## **Addendum 5**

#### **RFTMA26-5334 - New School Construction Mayfield West No. 2 Public School**

**PROJECT NO. 24112**

**ADDENDUM NO. 5**

CONCRETE STORAGE UNIT CONCRETE PAD  
TYPICAL AT ALL CONCRETE STORAGE BUNKERS. REFER  
TO SITE PLAN FOR LOCATIONS

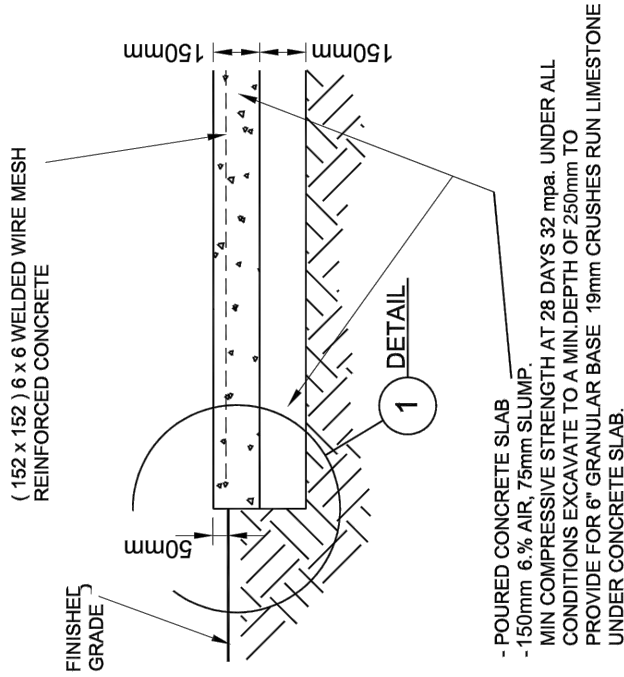
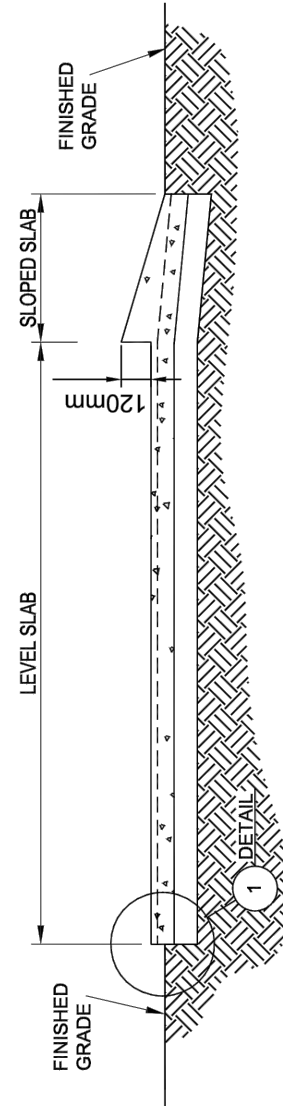
QUESTION 3: Section 10 44 00 – Please confirm the quantity of concrete storage sheds as drawing SP1 shows 5 and the specifications call for 4.

.1 REPLACE AD 208 Concrete Storage Unit Concrete Pad with enclosed AD 208 Concrete Storage Unit Concrete Pad dated July 28, 2026. Attached.

- .1 REVISE annotation at Concrete Shed adjacent to Garbage Bin Enclosure to read:  
“CONCRETE SHED ON REINFORCED CONCRETE PAD. REF. 44/SP2 **AD208** AND SPECS. (TYP.)”
- .2 REVISE size and location of Garbage Bin Enclosure including adjacent concrete shed per enclosed SKA A-202 REVISED SIZE AND LOCATION OF GARBAGE BIN ENCLOSURE dated July 28, 2026. Attached.
- .3 REVISE annotation tag to read:  
“MOVEABLE SOCCER GOAL POST 44/SP2 **N.I.C.**”
- .4 ADD all heavy-duty asphalt hatch patterns (2 areas) on SP1 Site Plan per enclosed CV-2 GRADING PLAN dated August 4, 2026. This is to clarify the delineation of medium-duty and heavy-duty asphalt areas as annotated.

ANSWER 3: [Please see addendum below.](#)

- .1 DELETE drawing 11/SP2 MOVEABLE SOCCER GOAL POSTS.
- .2 DELETE drawing 13/SP2 GARBAGE ENCLOSURE DETAILS.
- .3 CLARIFICATION: For Garbage Enclosure details refer to enclosed AD220 A-H dated January 19, 2026. Attached.
- .4 DELETE drawing 14/SP2 CONCRETE STORAGE UNIT CONCRETE PAD.
- .5 CLARIFICATION: For Concrete Storage Unit Concrete Pad details refer to enclosed revised AD208 dated July 28, 2026. Attached.

AD  
220A

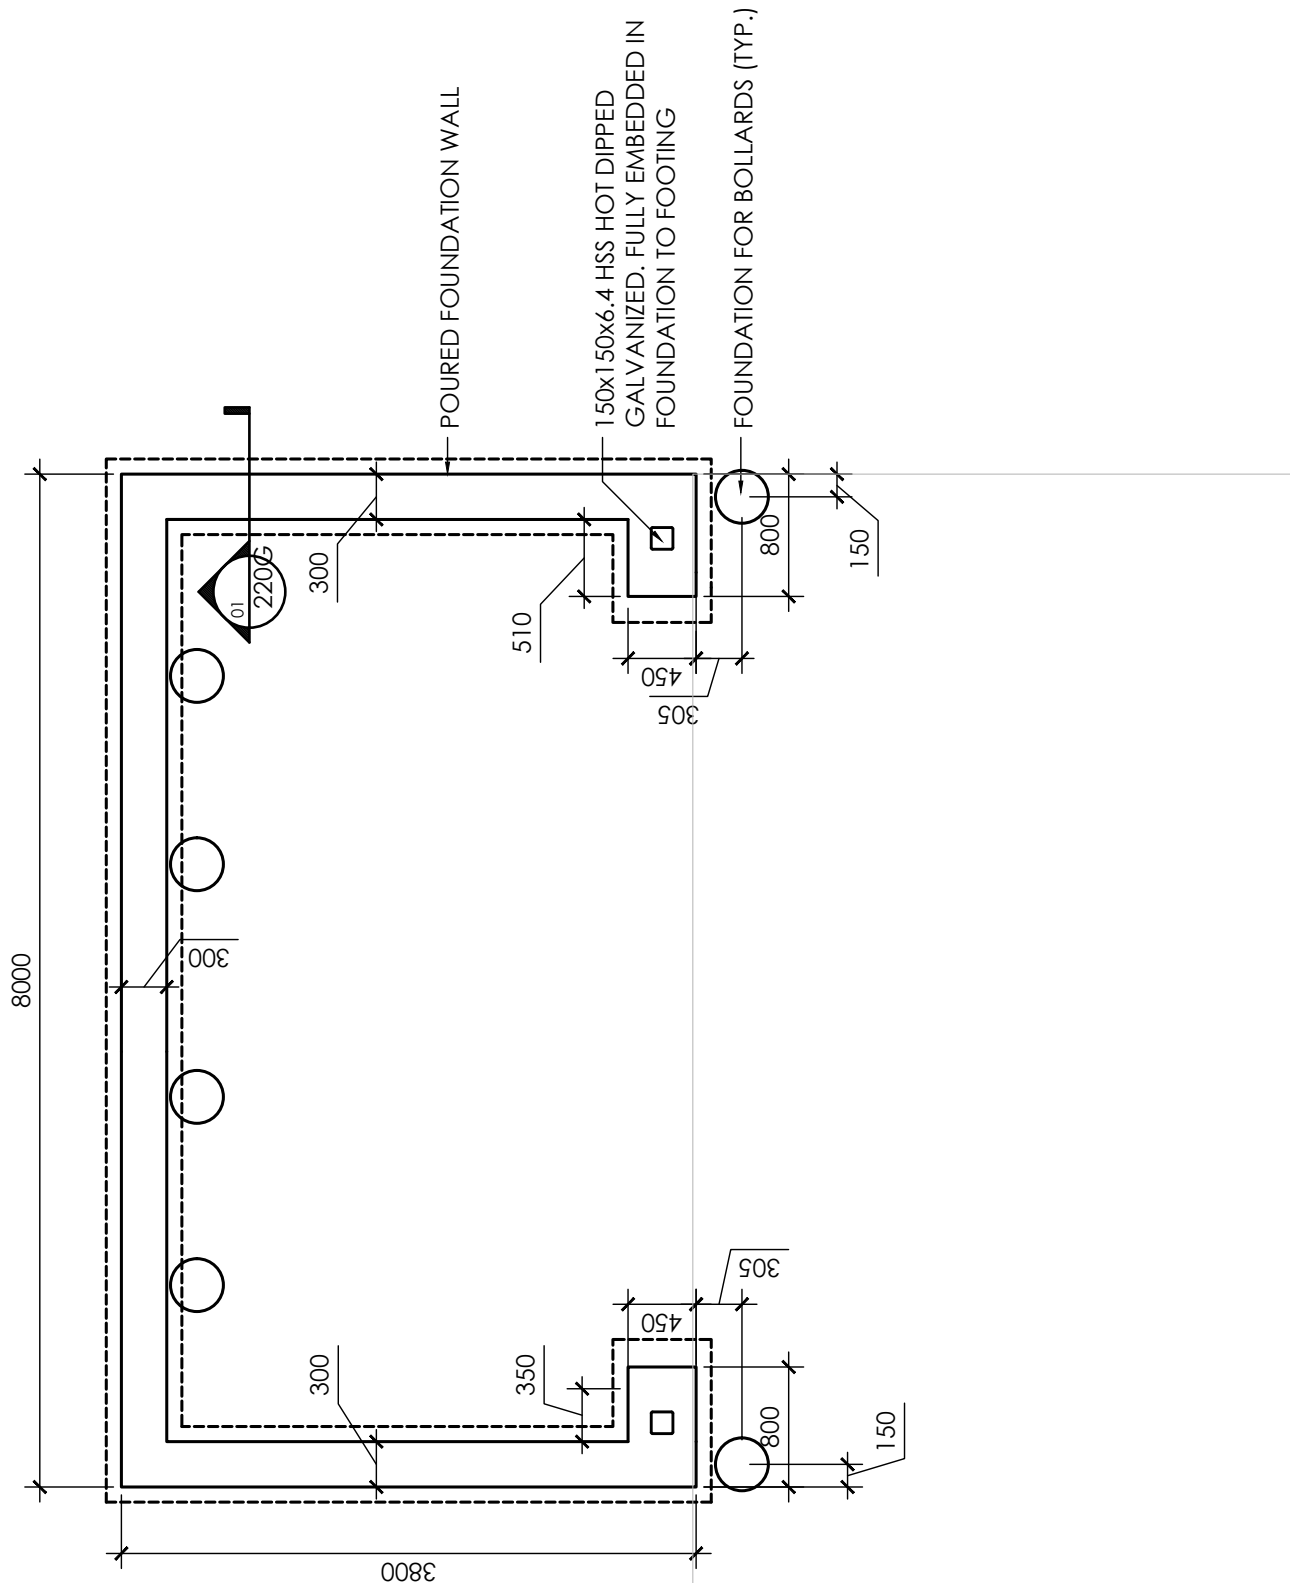
QUESTION 25: Drawing SP1 – shows the garbage enclosure which refers to detail AD220. AD220 cannot be found in the detail book. Please provide detail AD220.

- AD 220A Garbage Enclosure General Notes
- AD 220B Garbage Enclosure Plan View
- AD 220C Garbage Enclosure Foundation Plan
- AD 220D Garbage Enclosure Front Elevation
- AD 220E Garbage Enclosure Rear Elevation
- AD 220F Garbage Enclosure Wall Section
- AD 220G Garbage Enclosure Bollard Detail

ANSWER 25: [Please see addendum below.](#)

SUBDRAINAGE  
PLAN

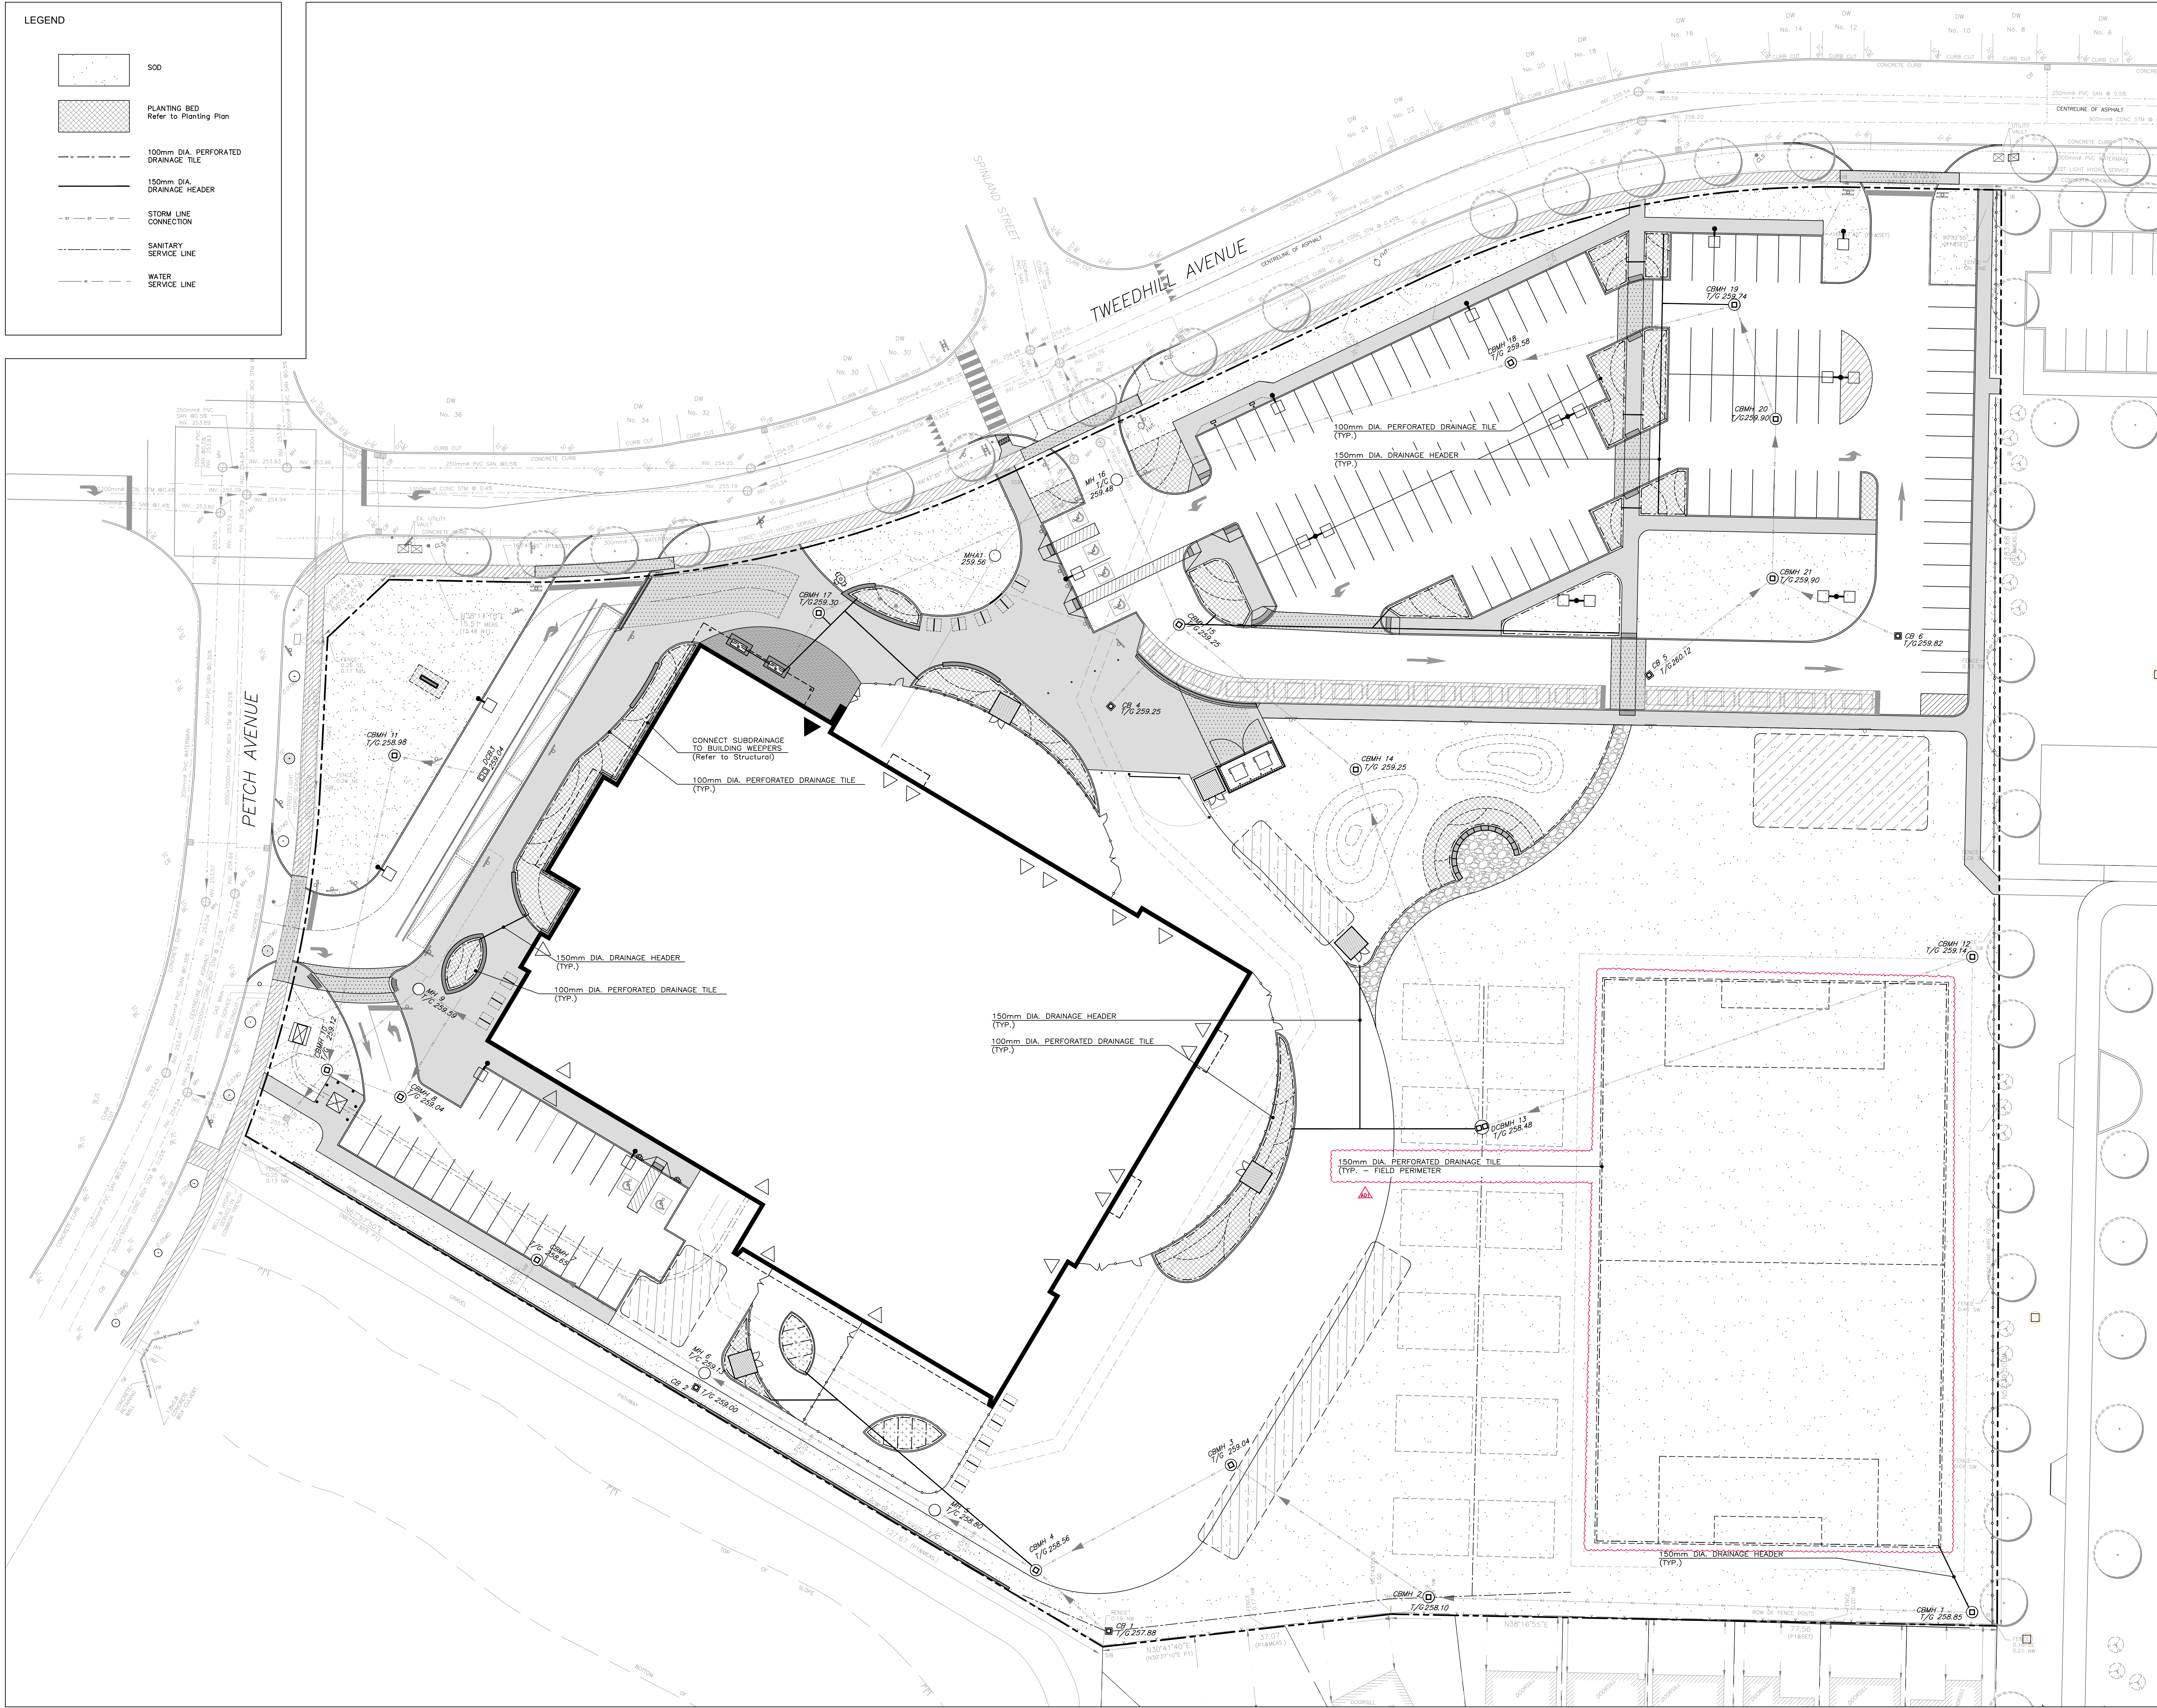
- .2 Revise field subdrainage to include a 150mm perforated PVC pipe around field perimeter only.
